ACCESSION NBR: 9610180150 DOC. DATE: 96/02/23 NOTARIZED: NO DOCKET #
FACIL: 50-244 Robert Emmet Ginna Nuclear Plant, Unit 1, Rochester G 05000244
AUTH. NAME AUTHOR AFFILIATION
MULLER, K.A. Rochester Gas & Electric Corp.
RECIP. NAME RECIPIENT AFFILIATION

SUBJECT: Rev 0 to "Inservice Testing Program."

GINNA PSA SYSTEM WORK PACKAGE PSA-06
CONTAINMENT SPRAY SYSTEM

Figure A-1

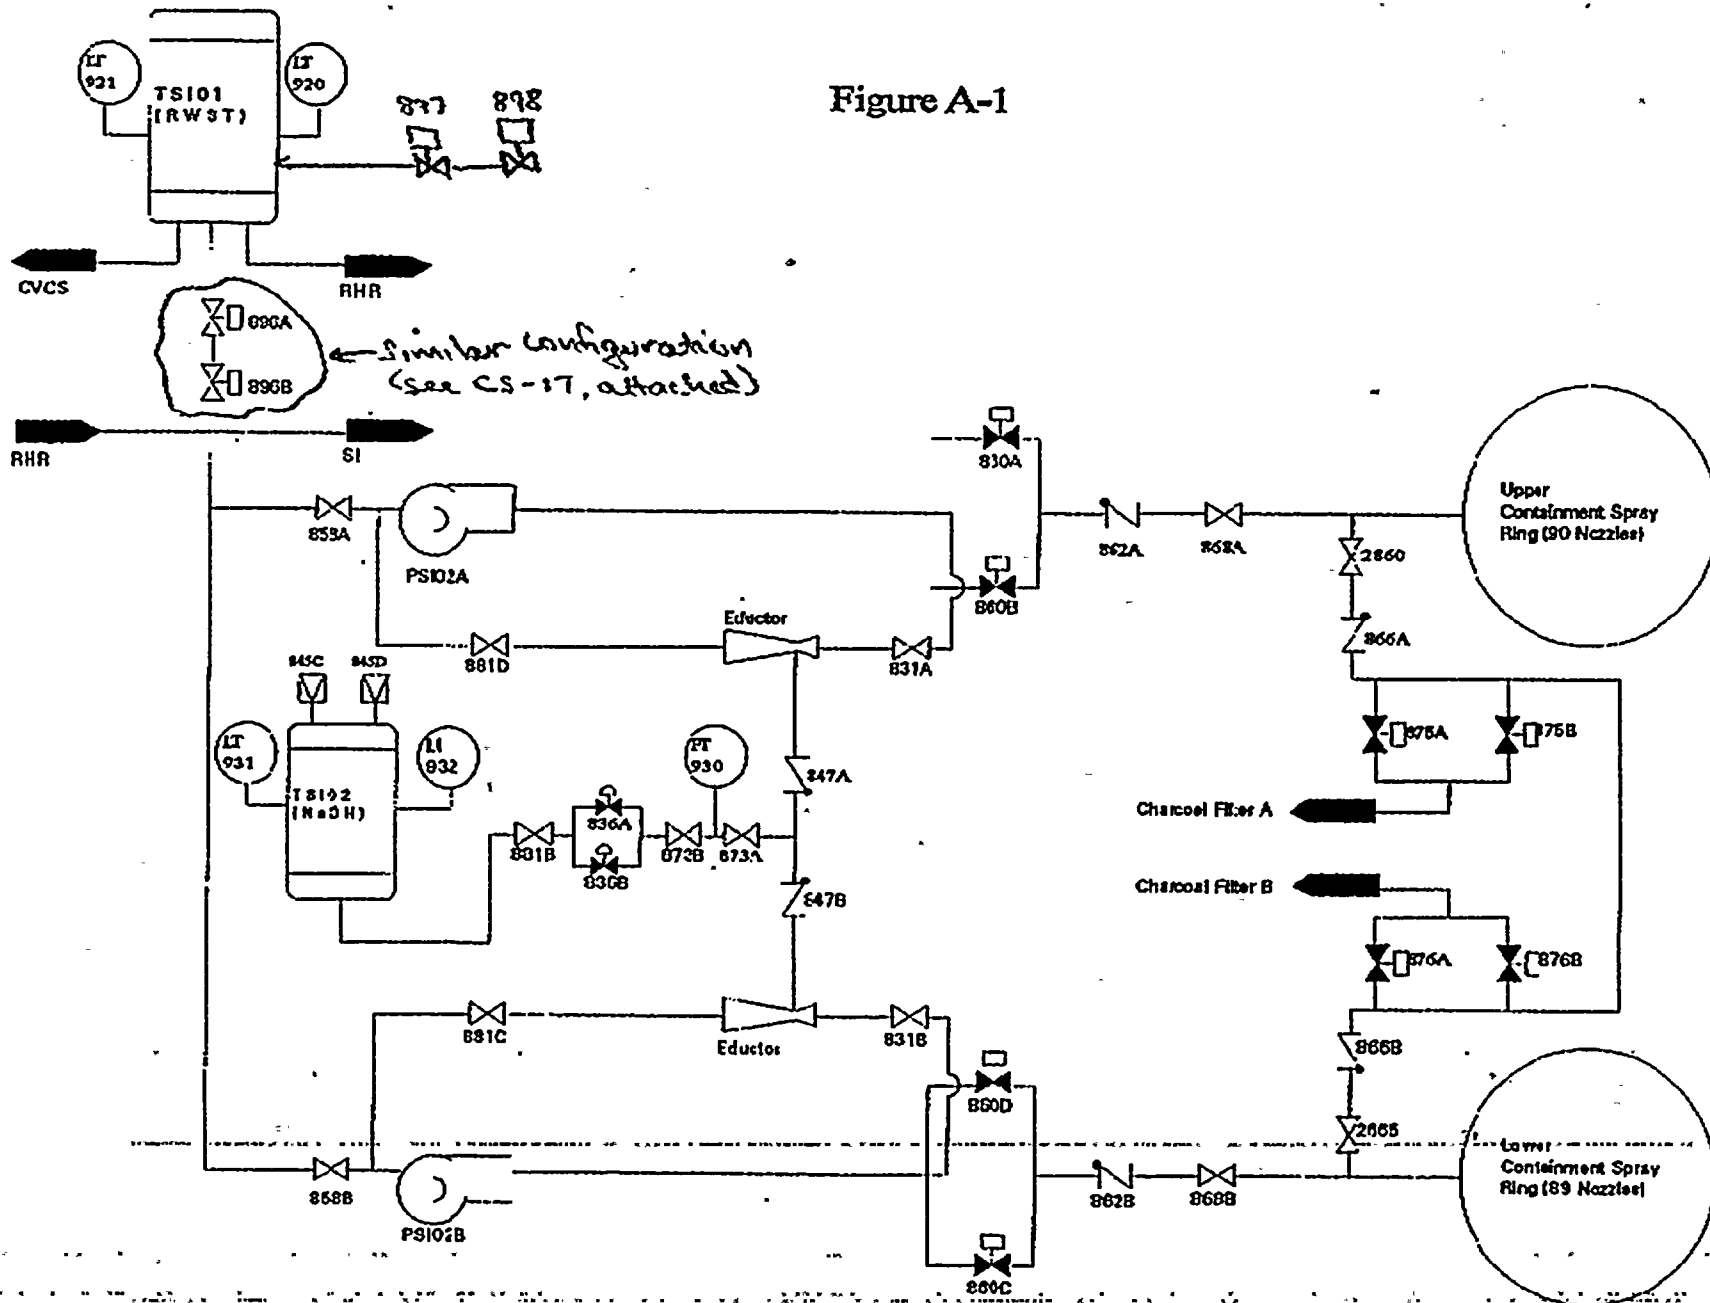
- (1) *One-line diagrams of the Safety Injection (SI) and Containment Spray (CS) systems which show the subject MOVs (897 and 898). These valves are required to be open during power operation since the ESPAS signal with respect to RCS pressure can actuate the SI pumps prior to reaching the shutoff head of the SI pumps (1700 psig versus 1400 psig). Therefore, maintaining the MOVs open ensures that the SI pumps are not deadheaded during the time frame it takes for the RCS pressure to drop from 1700 psig to 1400 psig. The valves are also required to be capable of closing during use of the SI system for high-head recirculation. That is, closure of the MOVs prevents the addition of highly radioactive sump fluid to the RWST. Per Technical Specifications LCO 3.5.2 and 3.5.3, at least one SI train must be operable above 200 F.*

- (2) *Copy of the Ginna Station IST Program With Respect to MOVs 896A and 896B. As shown on the one-line diagrams, MOVs 896A and 896B provide suction to the SI and CS systems. Per Cold Shutdown justification CS-17, RG&E only exercises these valves during cold shutdown since closure of the MOVs renders both SI and CS inoperable. This is very similar to the 897 and 898 valves.*

Based on the above, there is precedent for only exercising 897 and 898 at cold shutdown. The next required test of these valves is 11/11/96 (includes 25% extension). If the alternate testing frequency is not provided by this date, RG&E would be forced to enter LCO 3.0.3 to perform an ASME required test or shutdown Ginna.
